SYSTEMS REVIEW  
of the  
PALO VERDE NUCLEAR GENERATING STATION  
CLASS. IE AC POWER SYSTEM  
before the  
POWER SYSTEMS REVIEW BOARD

July 9, 1980

PALO VERDE NUCLEAR GENERATING STATION  
AC POWER SYSTEM REVIEW BOARD

FIGURE 1-4

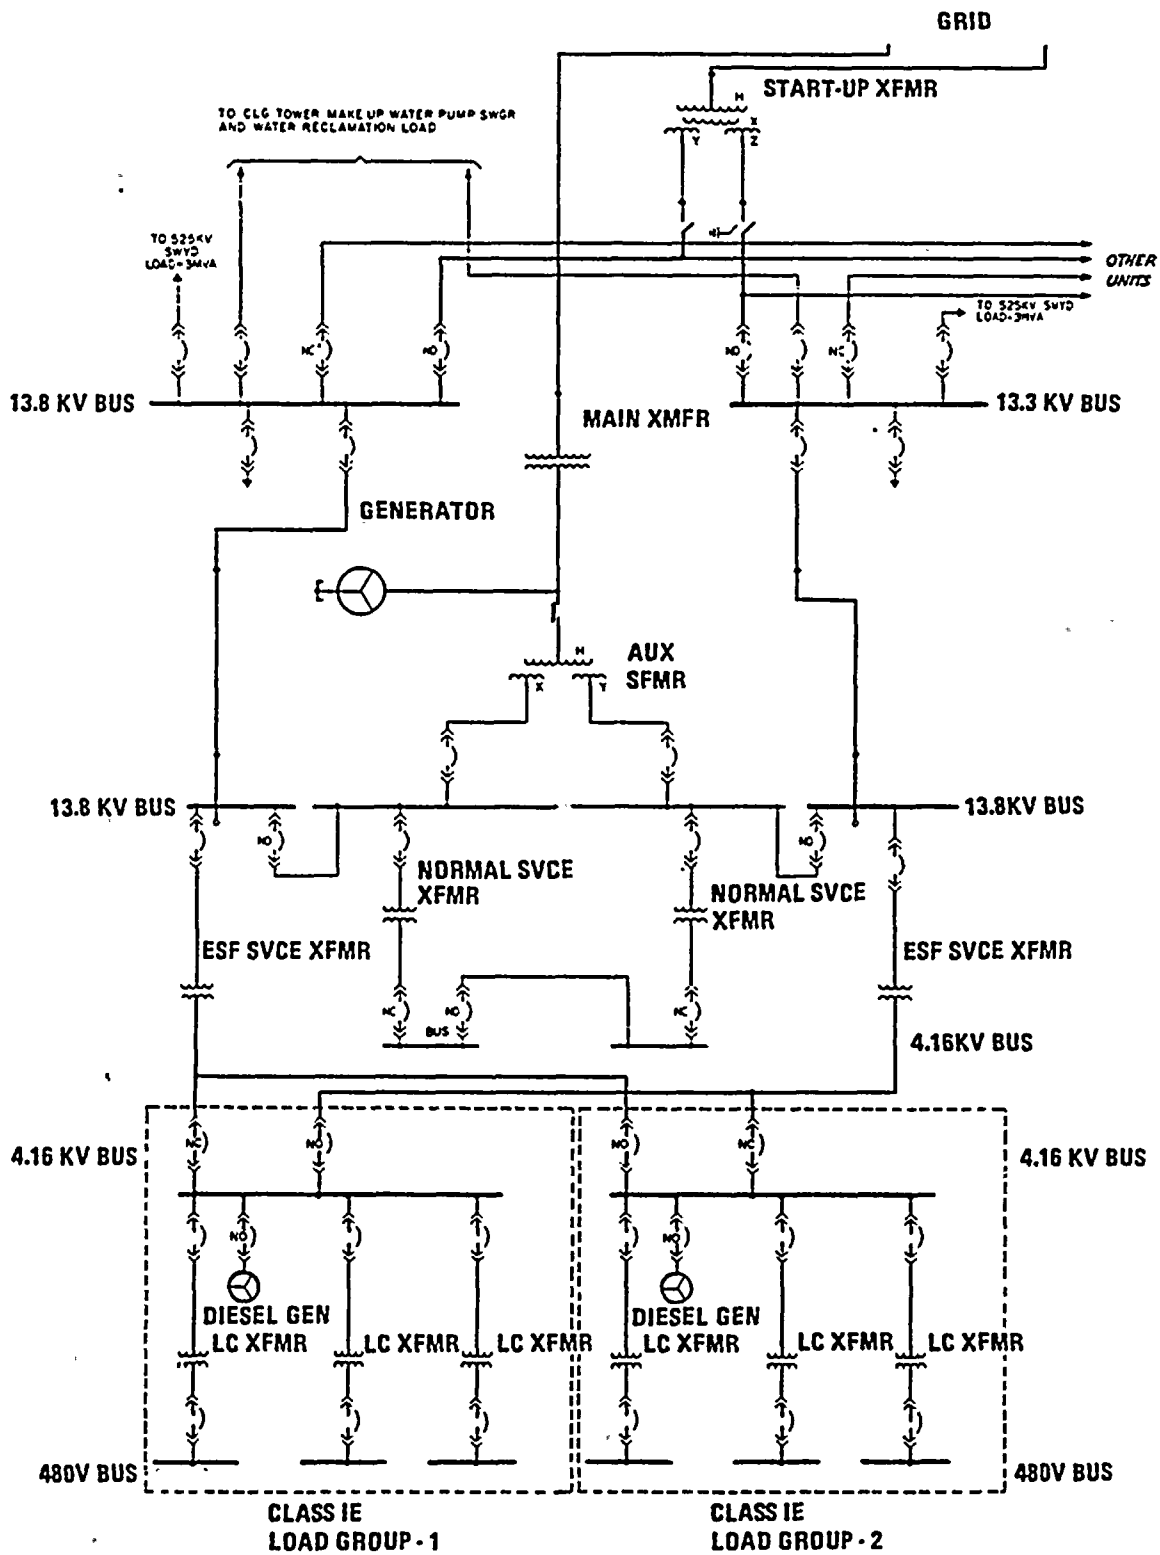
6 MR. FREID: Figure 1-4. In the diesel generator building,  
7 you show a double wall between train "A" and train "B"  
8 without any barrier in the upper part of that figure. I  
9 presume there is a fire barrier there closing off train "A"  
10 equipment room from train "B" equipment room?

17 MR. TAJADDODI: We will verify this. We do not have  
18 an answer for that. We can check that as an item to be  
19 looked into.

FIGURE 1-5

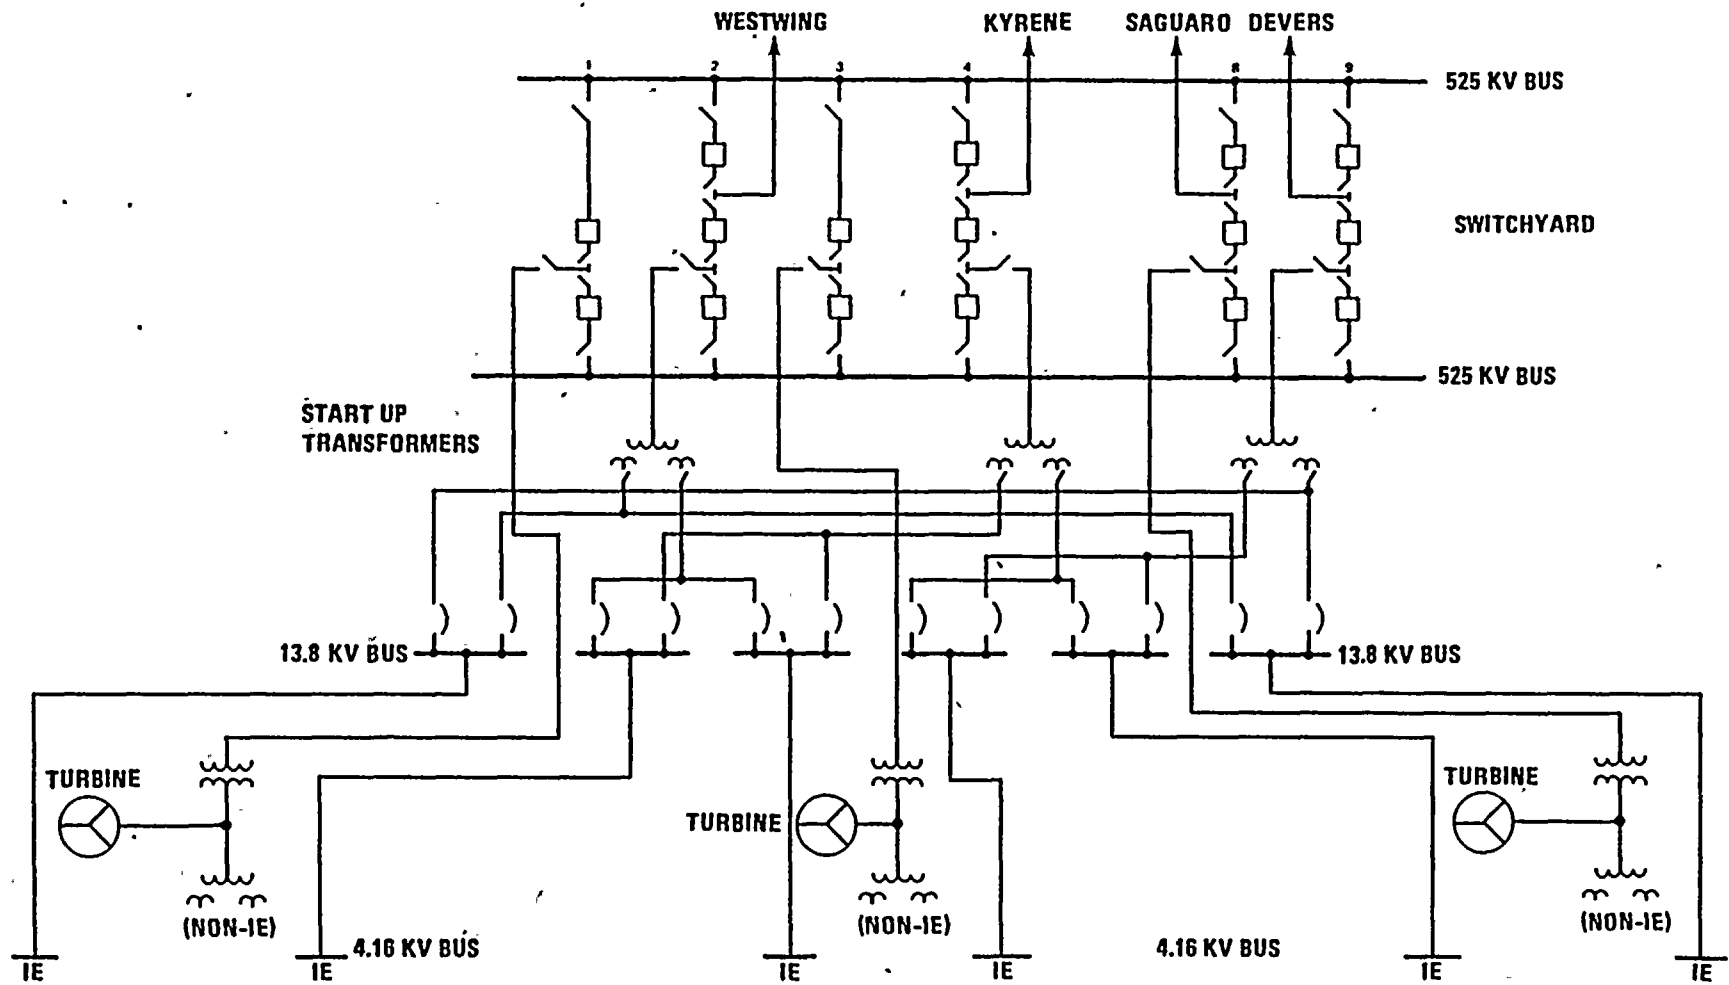
13 MR. KREUTZIGER: Yes. Kreutziger. Are we going to be  
14 discussing the area of technical specifications. Will we  
15 cover that later with respect to continued operations? I  
16 have a question. My specific question is a loss of ESF  
17 service transformer. You indicated in your discussion that  
18 you could lose an ESF service transformer and continue opera-  
19 tions. What are the technical specifications with respect  
20 to providing two sources of power to ESF buses on loss of  
21 one of the ESF service transformers.

9 MR. KREUTZIGER: I see very well that there are two  
10 immediate access circuits for ESF buses in the normal line up,  
11 my question came to providing -- whether or not there was  
12 any technical specification when the ESF transformers were  
13 out of service to provide -- whether or not there was an  
14 operating restriction on time. Whether or not there was  
15 another means whereby a second access source would be  
16 provided to the ESF.

3 MR. KREUTZIGER: One other question. Has the project  
4 purchased a spare ESF transformer? I would assume the ESF  
5 service transformers are equal size for all six service  
6 transformers?

16 MR. QUINN: Yes, Bill Quinn. The first item that I  
17 have is: was a spare ESF transformer purchased? This was  
18 in reference to figure 1-5.

1 requirements of Reg Guide 1.32 and IEEE 308 call for at least  
2 one source of offsite power normally all of the time. Now, if  
3 this normal source of offsite power for all of these load  
4 groups fail, these ESF transformers have capability such that  
5 it can provide power to both of these load groups simul-  
6 taneously. It has the capacity for doing so.

7 Now, you can operate indefinitely in this mode as long as  
8 there are no subsequent signals coming in such as the SIAS  
9 or other accident signals. If that happens, all of these  
10 breakers are going to be tripped. But as long as there is no  
11 emergency and you are operating in the normal mode, you can  
12 operate. You can align these breakers and this transformer  
13 here can provide power to all of these sources and this is  
14 allowed per the SRP. You can do this as long as you have  
15 two breakers in series such that you will negate the proba-  
16 bility of violating the single failure criteria.

17 MR. TAJADDODI: I understand your question now. Yes,  
18 there is. You are saying, how long can you operate under  
19 that mode?

1 which tells you that you can operate for a limited period of  
2 time if you lose one source of offsite power. Actually, that  
3 is tantamount to losing an offsite source of power. So if  
4 you lose one source of offsite power, you are allowed to  
5 operate for 72 hours continuously and then if you cannot  
6 restore the source of offsite power, you are supposed to  
7 bring the plant to a shutdown mode. Does that answer your  
8 question?
